C.O. 22

DRAINAGE PROFILE

KUAKINI HIGHWAY DRAINAGE IMPROVEMENTS
Vicinity of Mile Post 114
Project No. 11B-01-20

SHEET No. P-6 OF 10 SHEETS

△ PROFILE - DRAINLINE A

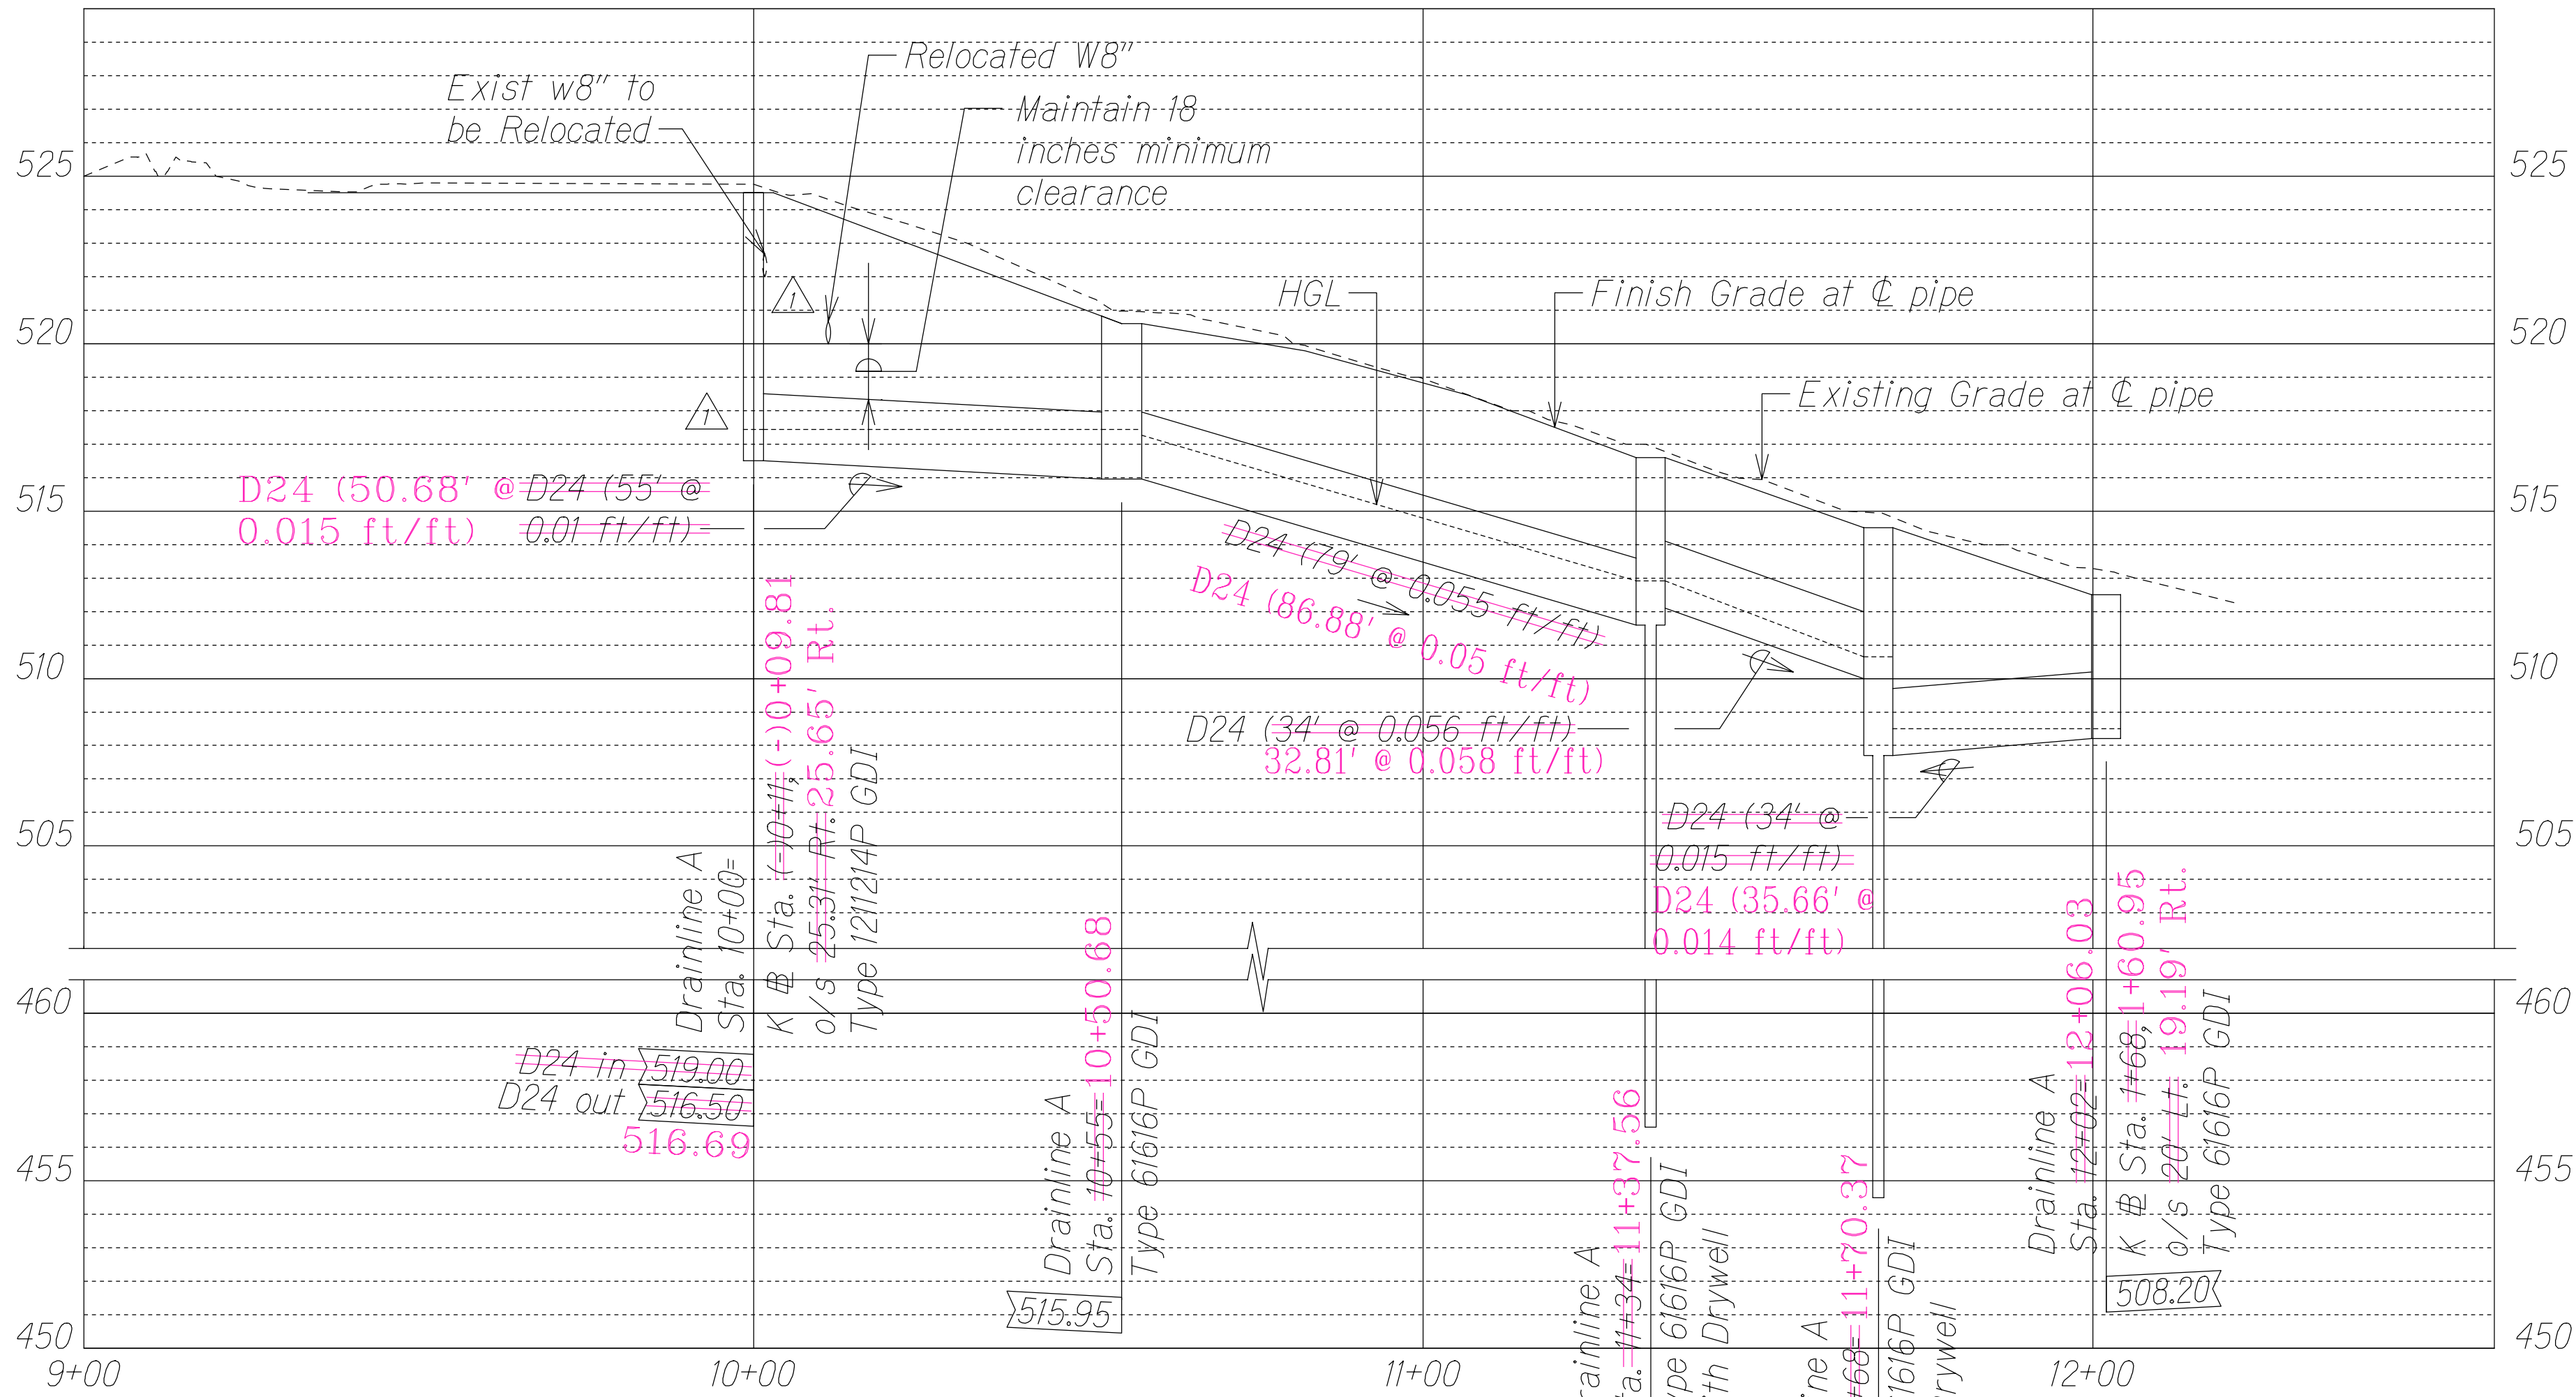
△ 10/28/22	Added Relocated Waterline Profile; Revised Profile Drainline A
△ 06/08/23	Revised Gutter Profile
Date	Revision
